Summary of LEB Discussions for the LHCB VELO Upgrade for LS2

Mark Antony Gallilee
*for the LHC Experimental Beampipes (LEB)
Working Group*

Requested change

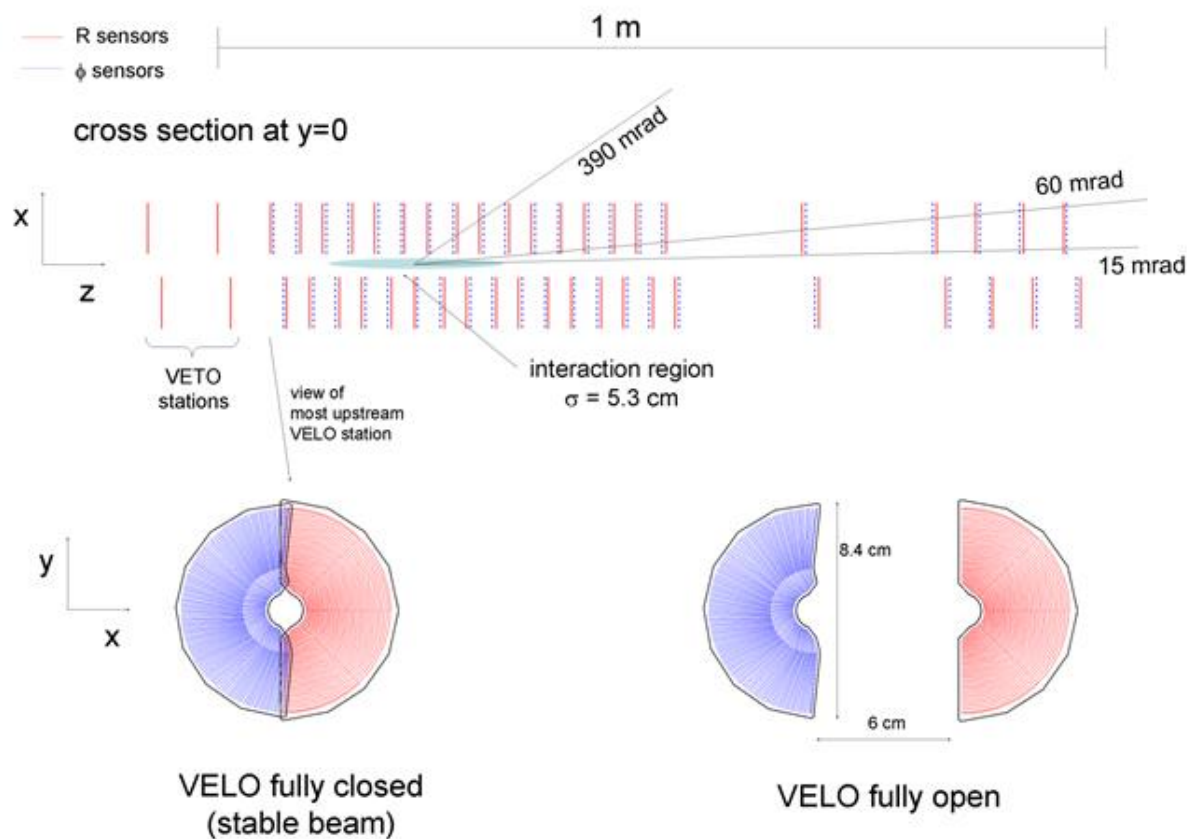
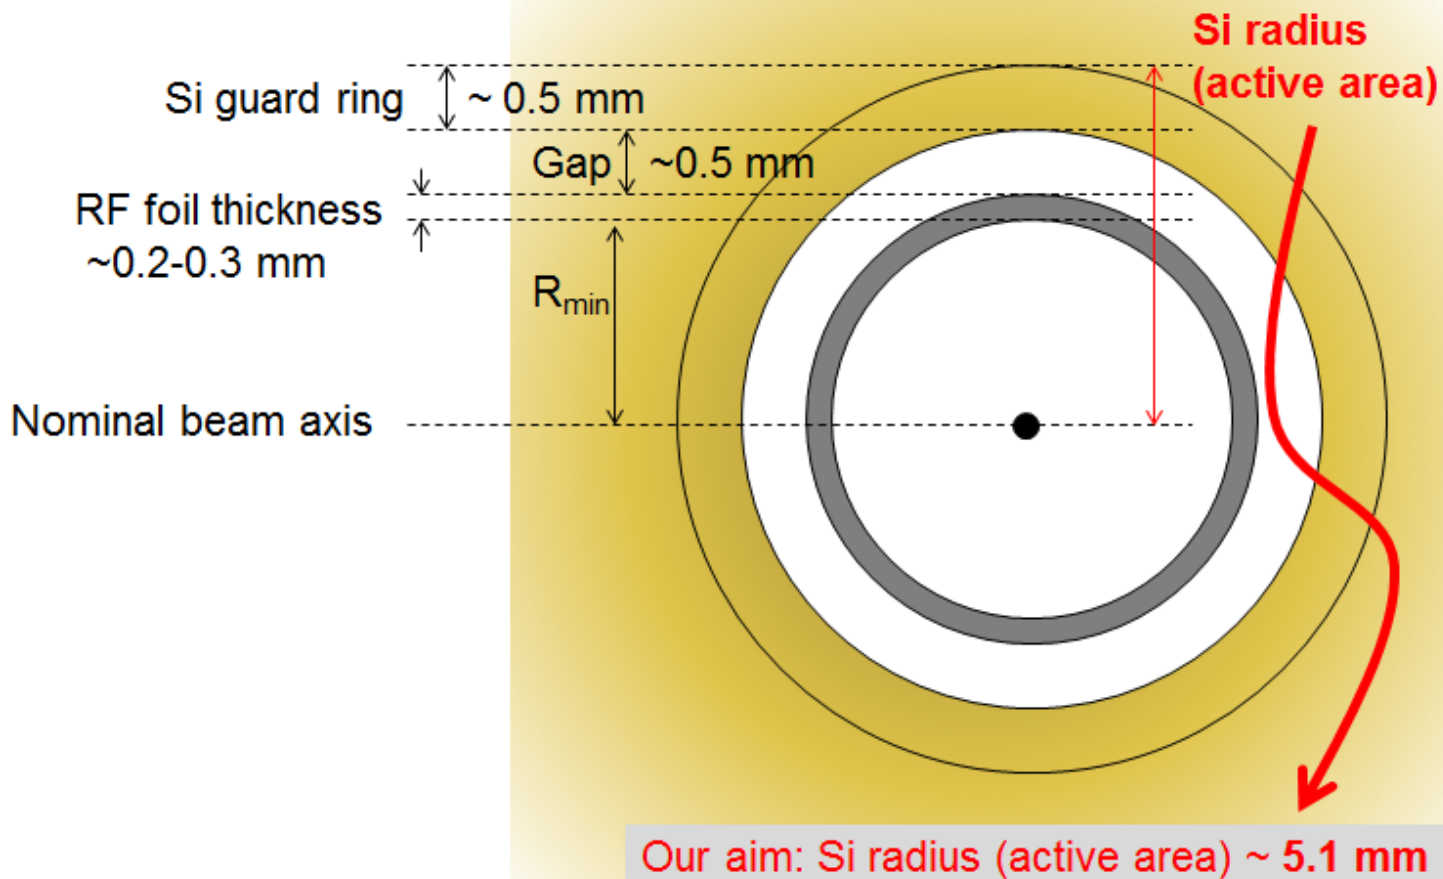
The various bits we would liketo minimize

Results

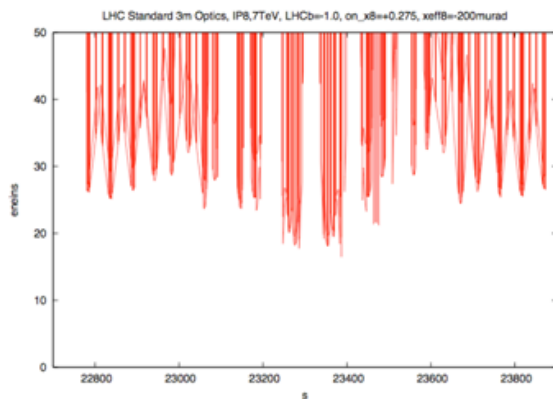
- Beam-beam separation
 - VELO aperture (beginning of fill): 63σ (assuming 25 ns nominal emittance).
- Beta* levelling
 - Vertical external crossing angle kept constant while β^* is varied.
 - VELO aperture (beginning of fill): $\approx 31 \sigma$ (assuming 25 ns nominal emittance).

LHCb = “bad”
(Positive kick on beam 1)

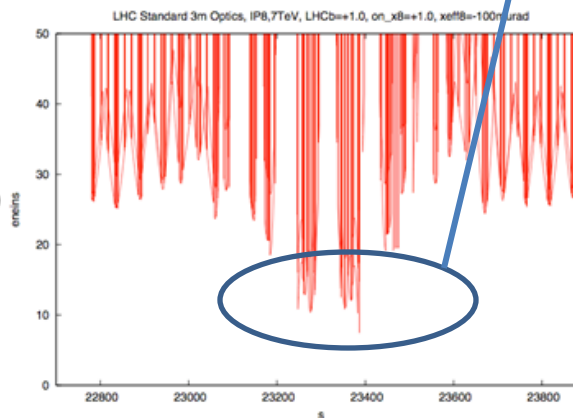
LHCb spectrometer polarity could have general aperture implications for LHCb 25 ns running – needs to be addressed

Preliminary results for the LHCb VELO radius reduction (5.5 mm to 3.5 mm)

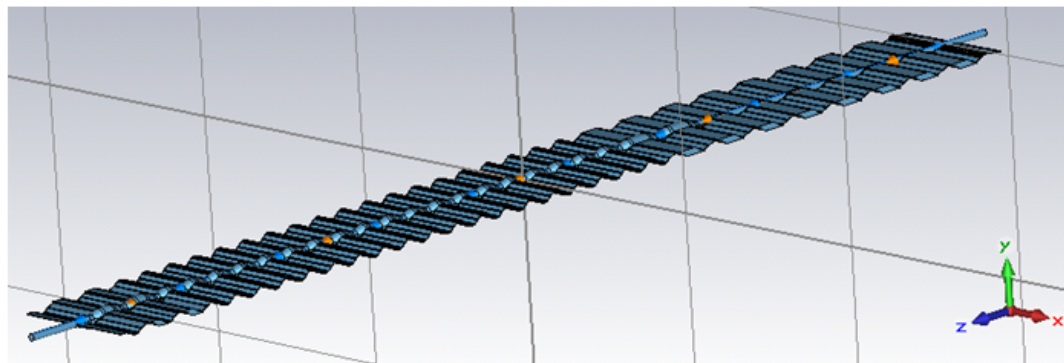
Final geometry not known → current geometry roughly scaled by 2/3 in both transverse directions.
Very twisted shape → difficult to import 3D model, low accuracy of simulations, convergence issues,
far from analytical models

With the current model, the radius decrease is expected to lead to an increase of the transverse impedance estimated to be up to 0.5% of the total transverse LHC impedance, despite the low beta function at the VELO location (up to 15 m). Unexpectedly, the longitudinal impedance in fact decreases with this smaller radius. Actual impedance and power loss with post-LS1 and HL-LHC parameters need to be checked and optimized when the final geometry is known.
